TECHNICAL DRAINAGE STUDY UPDATE No.3

**Skye Canyon
(Phase 2 Infrastructure)**

Job No.: OLY1501.001

Subject: Technical Drainage Study Update No.3 for Skye Canyon Ph.2 Infrastructure

Section - ECA2 (Ultimate Condition)

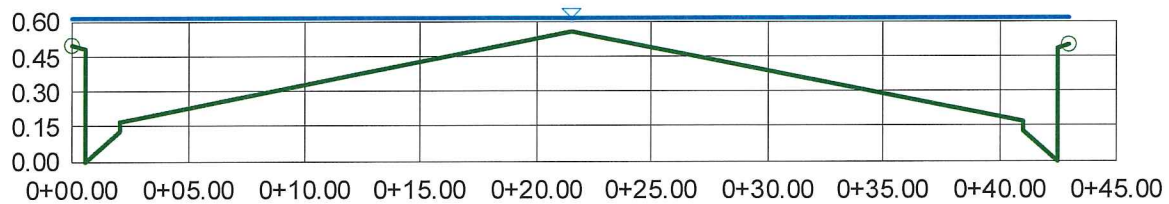
Flowmaster, Section ECA2 yields a velocity higher than 5 ft/s and depth above curb; however, HEC-RAS sections show the overbank velocity above the curb that would occur on the potential landscaping is non-erosive (2.13 ft/s) and does not require mitigation. The output file from the HEC-RAS model has been provided in Appendix C for reference. The HEC-RAS stations analyzed correspond to the street stationing along Eagle Canyon Avenue and the cross-sections have been indicated on the revised Ultimate Condition Drainage Map (Exhibit E) provided in Appendix A for spatial reference.

SKYE CANYON II PHASE 2 MASS GRADE
EGAN CREST STORM DRAIN PLAN AND PROFILE
"ECD" 28+50.00 TO "ECD" 34+00.00

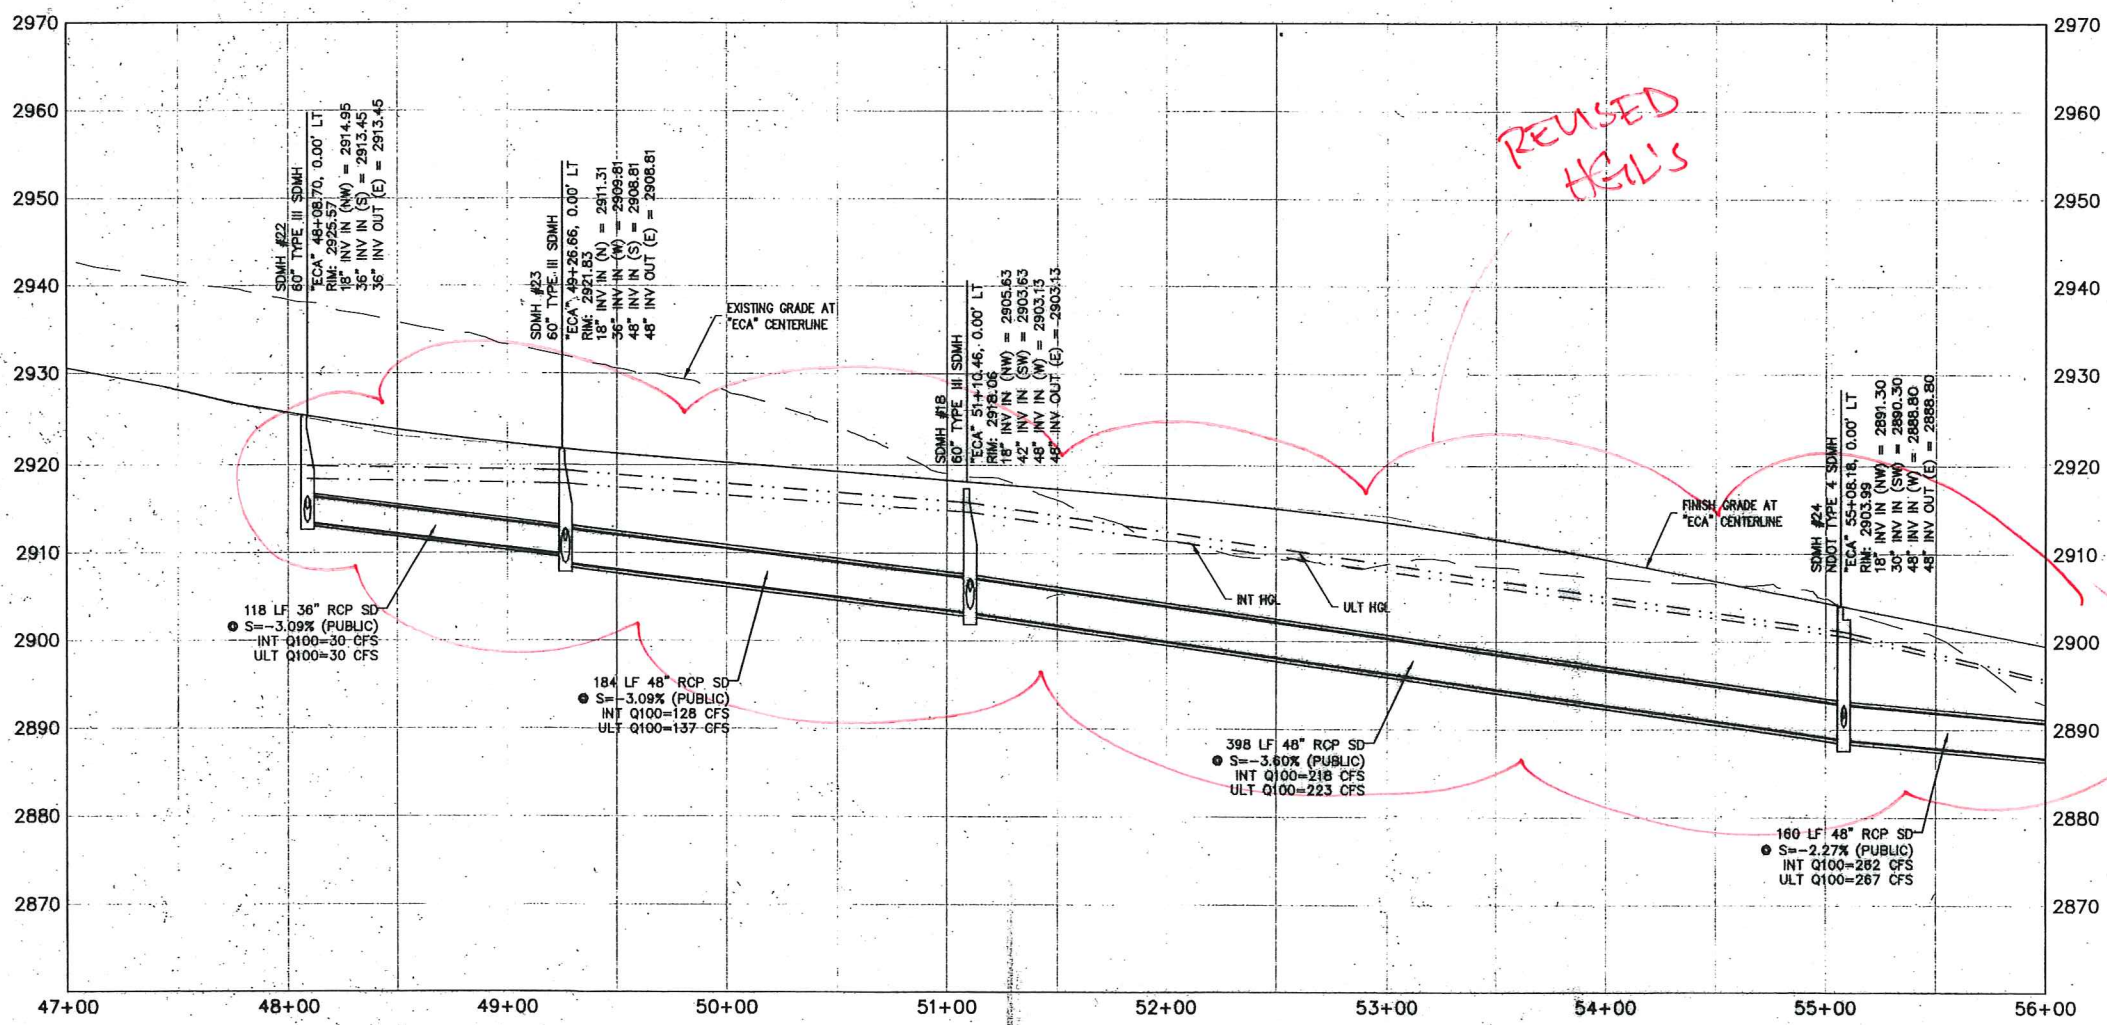
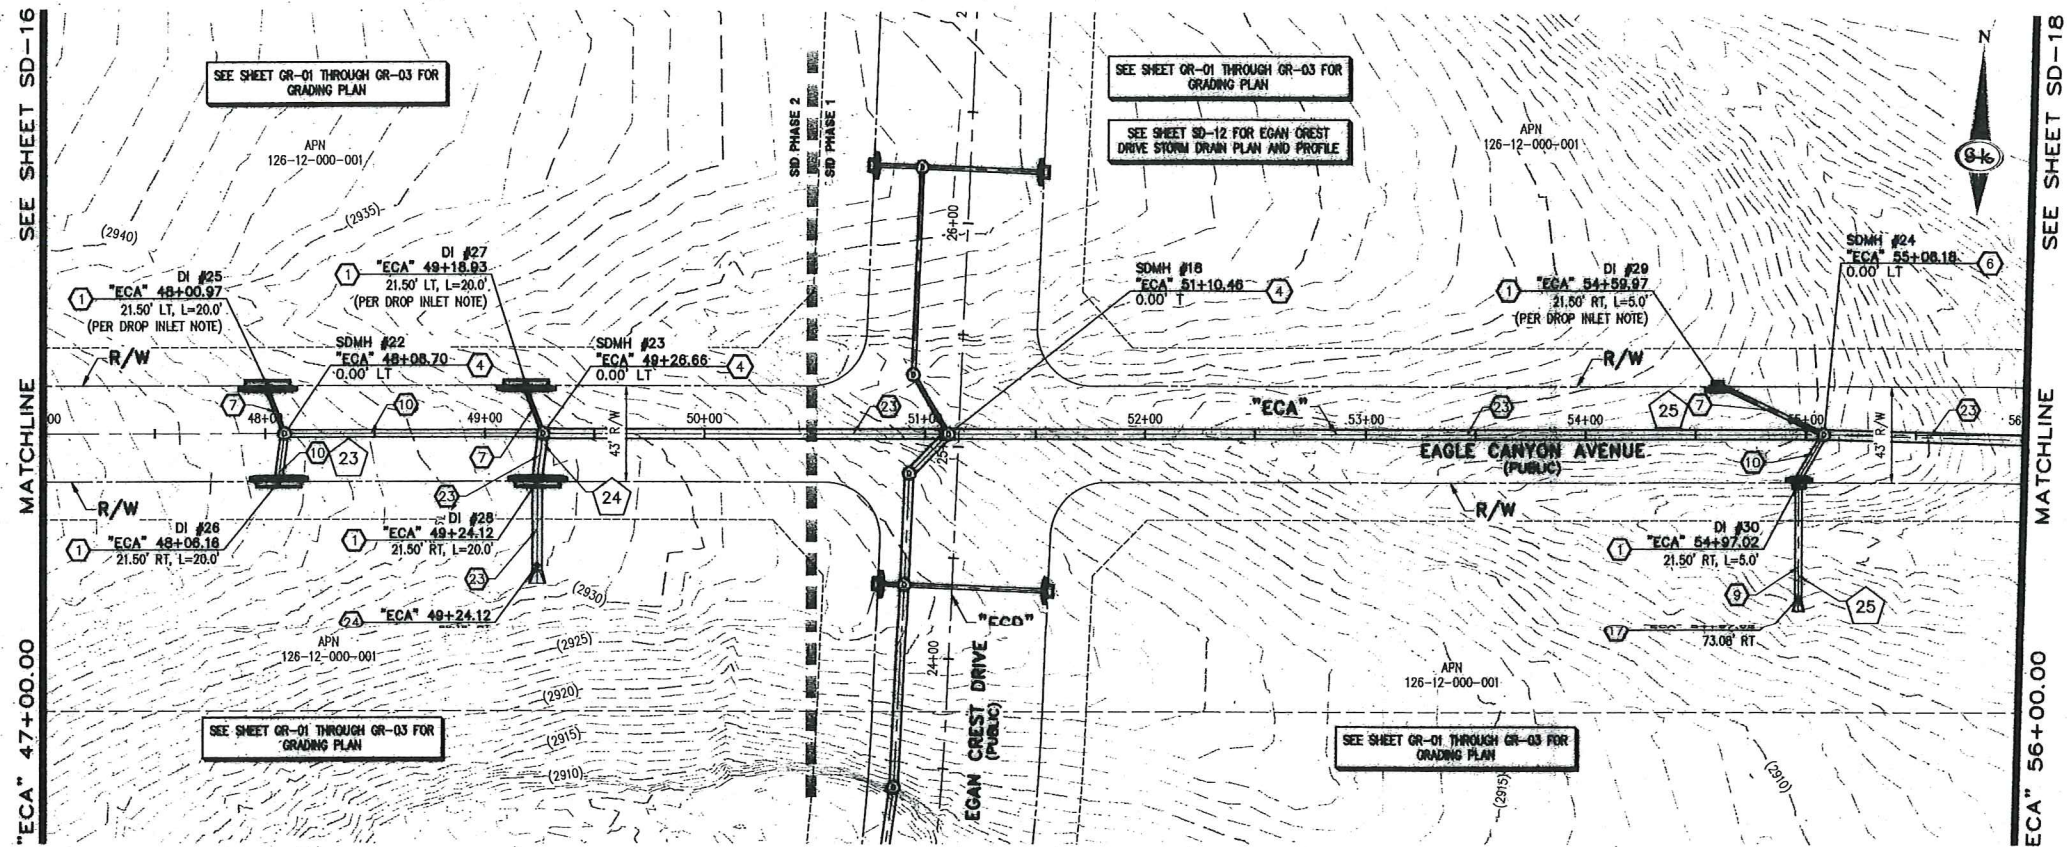
The location of the drop inlet and storm drain stub (Facilities P9 & L12) located on Egan Crest Drive north of Eagle Canyon Avenue are being revised to correctly align with Skye Arroyo Avenue (the interior street of Parcel 2.16) conveying the flows generated from the development

of the parcel to the storm drain stub. The WSPGW hydraulic analysis of the revised storm drain alignment and profile has been provided with this submittal. Note that the size of the relocated drop inlet has been increased from a 7.5-ft to a 10.0-ft Type CM2 to accommodate the skew of the lateral stub. The inlet computation has not been revised since the new inlet is slightly bigger than that previously proposed which also intercepted all the available surface flow in the street. The pertinent revised infrastructure plan and profile sheets have also been provided with this submittal.

SKYE CANYON II PHASE 2 MASS GRADE
EAGLE CANYON AVENUE PLAN AND PROFILE
"ECA" 47+00.00 TO "ECA" 56+00.00

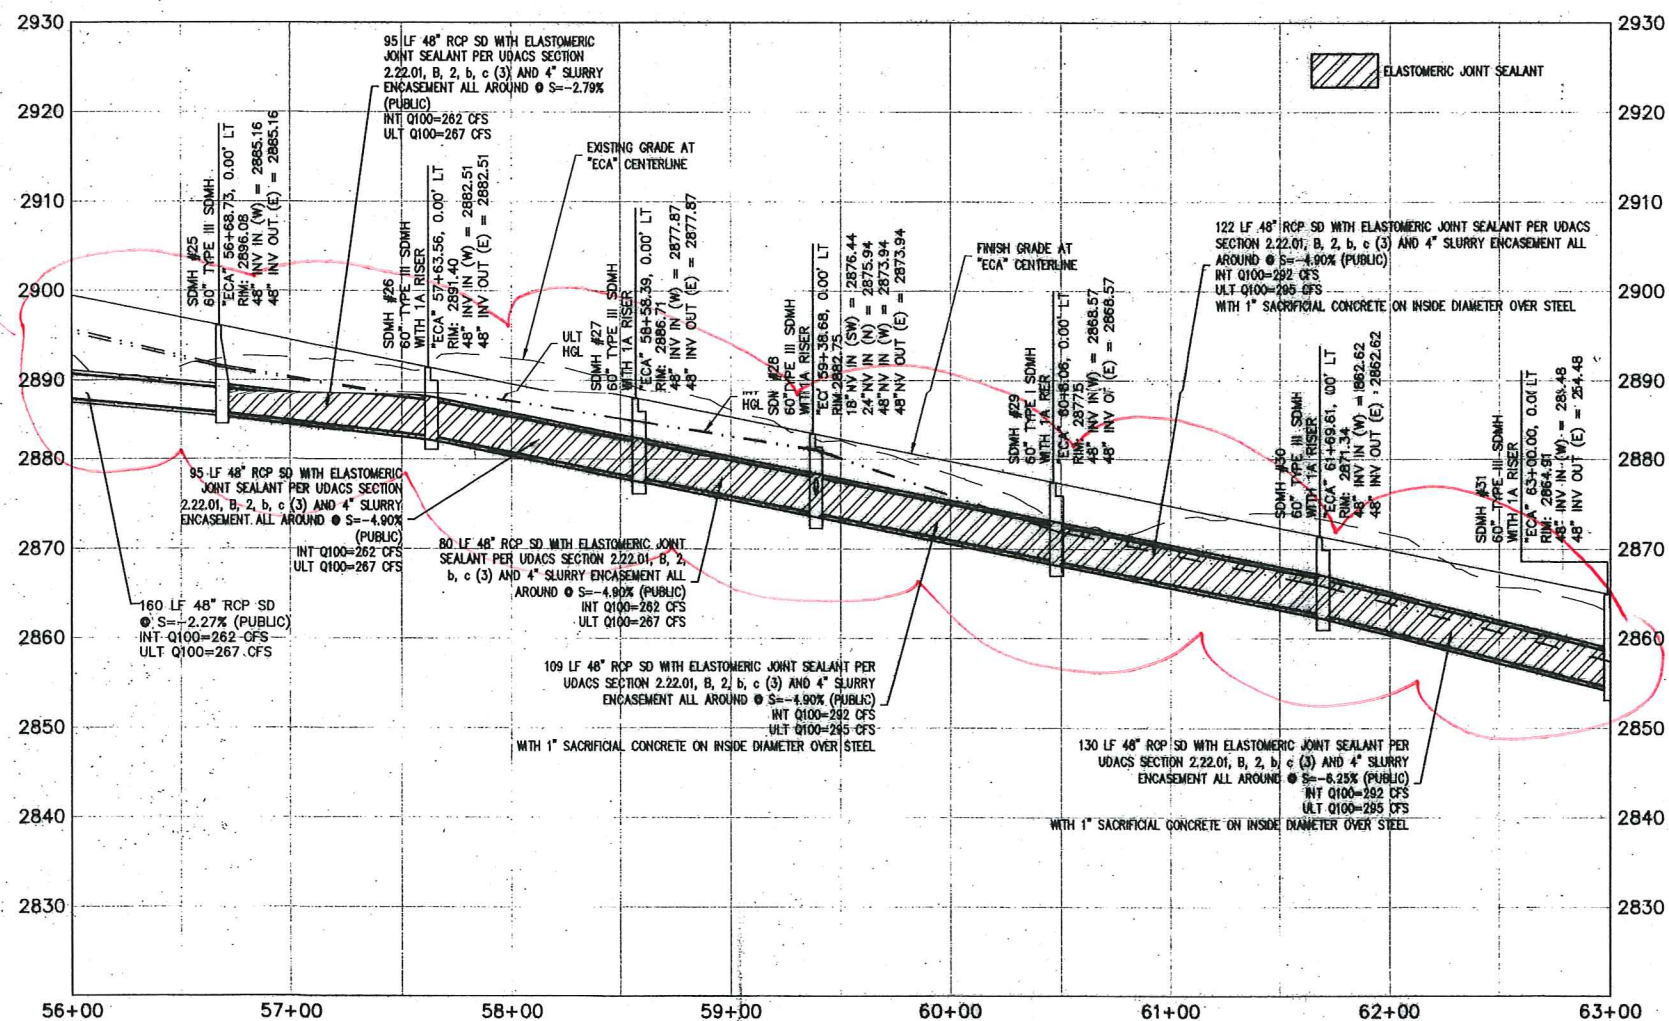
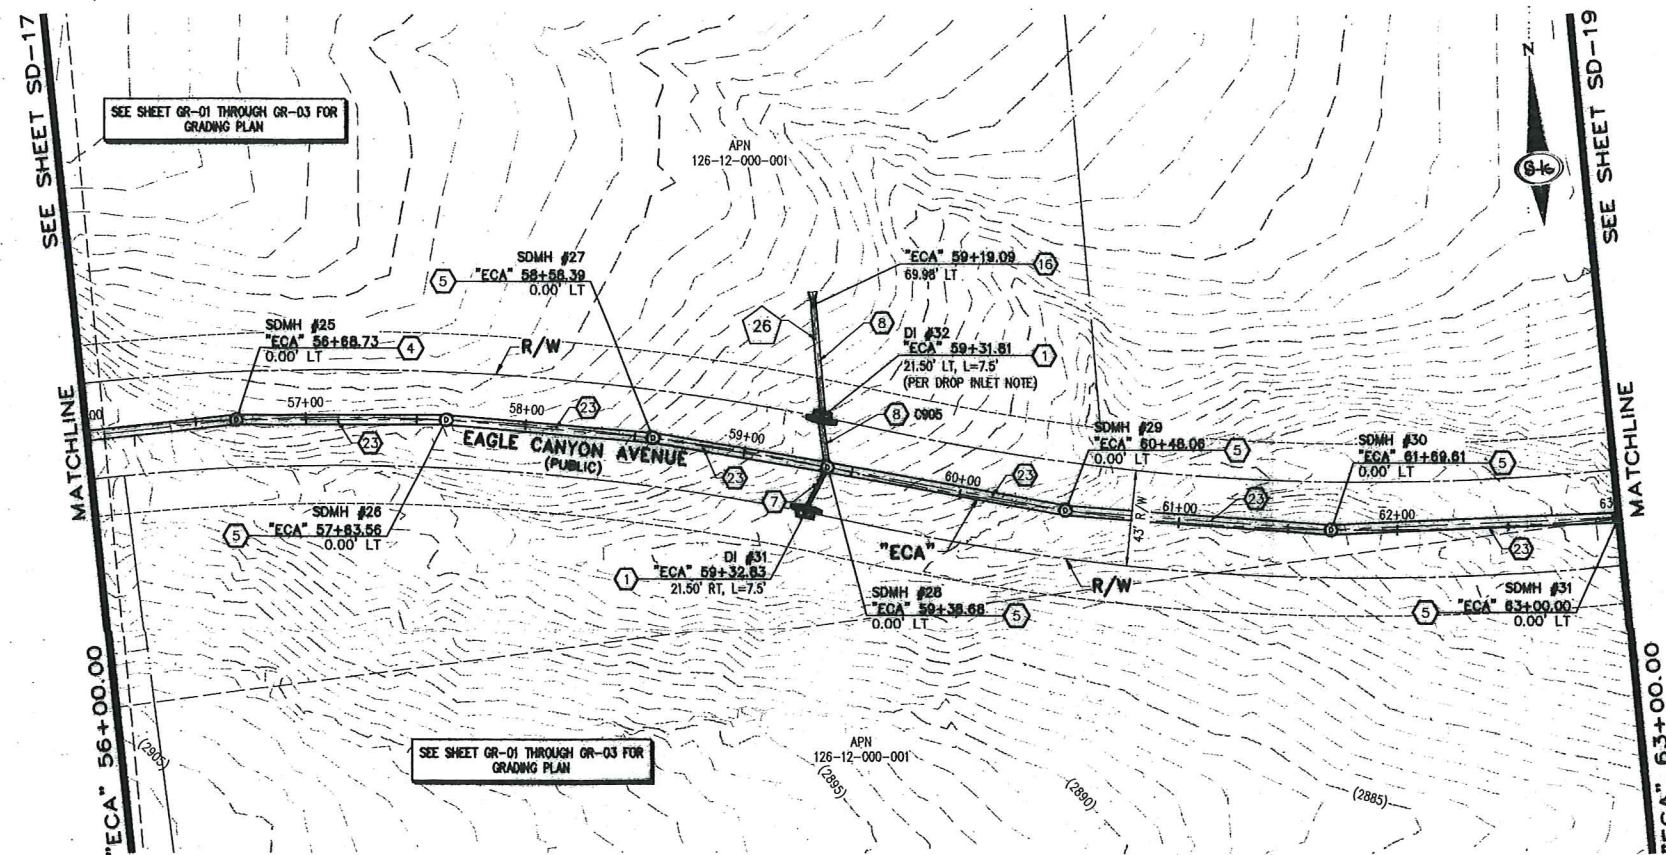
- Minor lateral shift of the drop inlet (identified in the Phase 2 Study as Facility P3B) located on Eagle Canyon Avenue just south of Egan Crest Drive at approximate station 49+00.00. The drop inlet will be laterally shifted approximately 5-ft to the east to accommodate the proposed sewer line to service Parcel 2.16.

The 20-ft long Type CM2 drop inlet (Facility P3B) located along Eagle Canyon Avenue just south of Egan Crest Drive at approximate station 49+00.00 will be slightly revised. The drop inlet will be laterally shifted approximately 5-ft to the east to accommodate the proposed sewer line to service the Parcel 2.16 subdivision. Note the storm drain lateral for the drop inlet will remain unchanged. Therefore, no revision to the inlet and lateral hydraulics will be necessary.
